Response to Request for Additional Information - ANP-10337 Supplement 1

ANP-10337
Supplement 1Q2NP
Revision 0

Topical Report

November 2019

Figure 4-1 Illustration of Primary and Secondary Stress

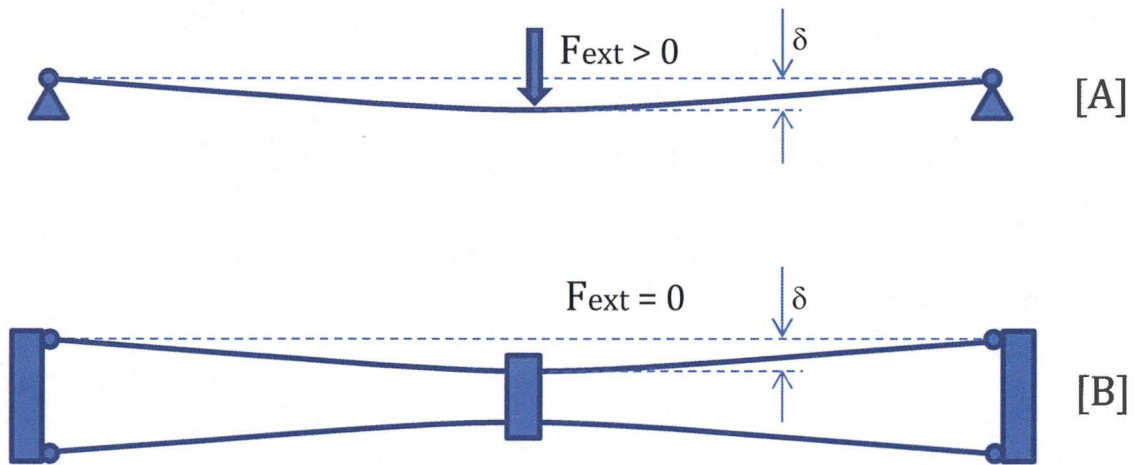
Identify and describe the primary and secondary stresses that affect the guide tubes and fuel rods in a Supplement 1 analysis. Also explain why the ANP-10337 control rod insertion test database and control rod insertion acceptance criteria remains applicable to Supplement 1 analyses that include the DGE.

The essential difference between primary and secondary stress is that primary stresses are necessary to maintain equilibrium with external loads, while secondary stresses are present due to the self-constraint of the structure, and are associated with an imposed strain pattern. To illustrate this point, consider the case of a beam on pinned supports (Figure 4-1-A). In this case the external force F_{ext} creates a displacement δ and a state of stress which is **necessary to maintain the equilibrium** with the applied external force. This stress is not equilibrating within the structure, nor is it self-limiting. If the external force increases, the stress has to increase as well in order to maintain equilibrium, and if the beam material yields though the section, the structure collapses. This case illustrates a typical primary stress. In Figure 4-1-B, the structure is composed of two beams and the same displacement δ is applied in opposite directions by a restraining device. In this case the beams experience the same state of stress as in case A, but these stresses are equilibrating within the structure. The structure is in equilibrium under zero external force, hence these stresses are not needed to maintain equilibrium with external forces, but arise from the self-constraint of the structure, which is forced to comply with an imposed displacement pattern. This case illustrates a typical secondary stress.
